PZ&B Staff Combination Memorandum: Landmarks Preservation Commission and Town Council

SUBJECT: ZON-24-0004 (COA-24-0001 126 S OCEAN BLVD (COMBO)

MEETING: JUNE 21, 2024, LPC

JULY 10, 2024, TC

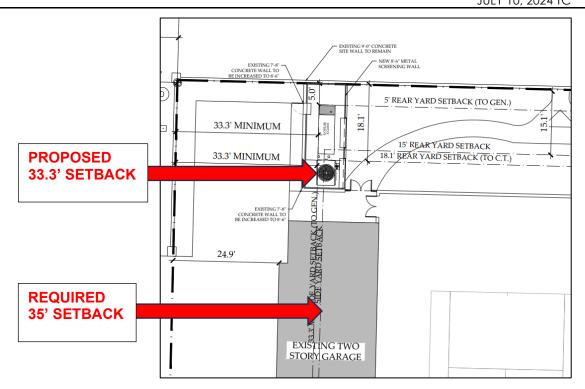
The application is seeking a Certificate of Appropriateness to renovate the existing mechanical equipment enclosure and increase the wall height to adequately screen the replacement cooling tower and generator. The existing enclosure is located on the northwest corner of the property with frontage on Flagler Drive. The existing pedestrian doors to the enclosure will be reused. The existing concrete wall with stucco finish and metal screening wall will be replicated within the revised enclosure configuration. However, staff have concerns about the repurposed gate's ability to adequately screen the mechanical equipment since the enclosure is being raised.

The application as proposed requires three (3) variances for construction. As the diagram below illustrates, **Variances 1 and 2** seek a reduced rear setback of 5' in lieu of the required 15' per Section 134-793(a)(9) and a reduced street-side yard setback of 33.3' in lieu of the required 35' per Section 134-793(a)(5).

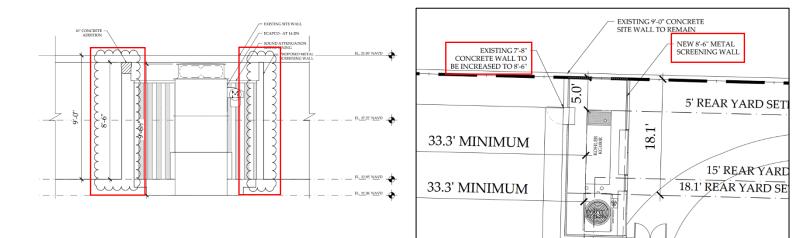
As the diagram below illustrates, **Variance 3** occurs because a higher enclosure wall height is needed to screen the replacement cooling tower and generator. The site wall/fence height variance request code section, provisions, and amounts are provided in the table below:

|   | Code Section                                  | Required                                                                           | Proposed                 | Variance                                         |
|---|-----------------------------------------------|------------------------------------------------------------------------------------|--------------------------|--------------------------------------------------|
| 5 | Variance 3:<br>Sec. 134-1667<br>Sec. 134-1669 | 7' – Max. Wall Height Side Yard<br>6' – Max. Wall Height Front/Street Side<br>Yard | 8.5'<br>Site Wall Height | 1.5'- Side Yard<br>2.5' – Front/Street Side Yard |
